# Access Compliance Report

## Public Rights-of-Way

Intersection ID: 4999	Main Street: E_MALLARD_CREEK_CHURCH_RD	Cross Street: STONE_QUARRY_RD	Location: S
ADA ID: CBDDC4B57F45	Ramp Type: Perp	Initial Pass/Fail: Fail	Overall Compliance: No
Severity Score: 22.5			
Codes/Mitigation Info/Possible Solution		Field Measurements/Component Compliance

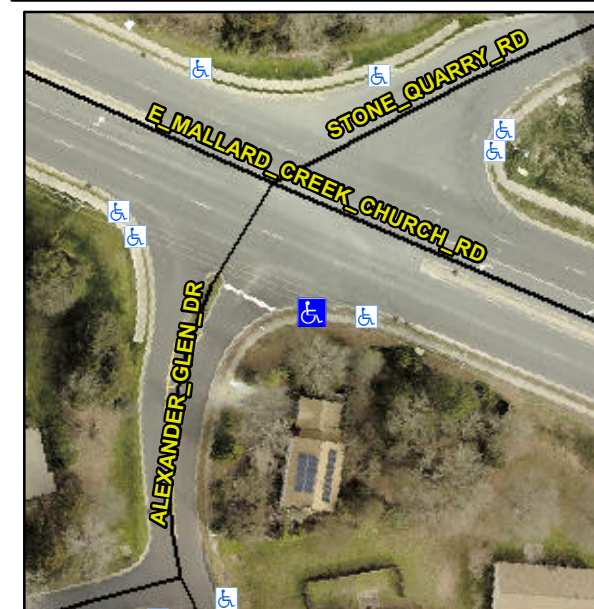
**R304.5.1, R304.2.2, R304.5.3**

Compliance	Description	Data	Compliance	Description	Data
N/A	Ramp Length (in)	68.0	No	Ramp Slope (%)	9.0
No	Ramp Width (in)	47.0	No	Ramp XSlope (%)	5.0
N/A	Flare Type LT	N/A	N/A	Flare Type RT	N/A
N/A	Flare Slope LT (%)	N/A	N/A	Flare Slope RT (%)	N/A
N/A	Flare Traversable LT?	N/A	N/A	Flare Traversable RT?	N/A
N/A	Landing Length (in)	N/A	N/A	DWS Provided?	N/A
N/A	Landing Width (in)	N/A	N/A	DWS Contrast?	N/A
N/A	Landing Slope (%)	N/A	N/A	DWS Length (in)	N/A
N/A	Landing X Slope (%)	N/A	N/A	DWS Full Width?	N/A
N/A	Landing Curb? (Y/N)	N/A	N/A	DWS Offset (in)	N/A
N/A	Shared Landing?	N/A			
N/A	Gutter Ponding?	N/A	N/A	Gutter Slope (%)	N/A
N/A	Gutter Lip Ht (in)	N/A	N/A	Gutter X Slope (%)	N/A
N/A	Painted X Walk1?	No	N/A	Painted X Walk2?	N/A
	X Walk 1 Direction	To NW		X Walk 2 Direction	N/A
N/A	X Walk 1 Width (in)	N/A	N/A	X Walk 2 Width (in)	N/A
	X Walk 1 Slope (%)	2.7		X Walk 2 Slope (%)	N/A
	X Walk 1 X Slope (%)	3.8		X Walk 2 X Slope (%)	N/A

**Remove & Replace Entire Ramp.**
